AMENDMENT TO THE POLICE FORCE OPERATIONS AND PARTS INFORMATION MANUAL

The following Amendments now affect the POLICE FORCE Manual. Please make sure you include them in either pen-and-ink form or copy-and-paste form in your manual.

Car Motor EMI Filter Board

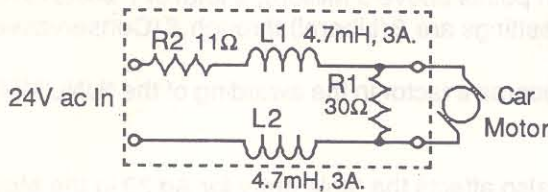
5. Add Page 79A, which provides information about the Car Motor EMI Filter Board.
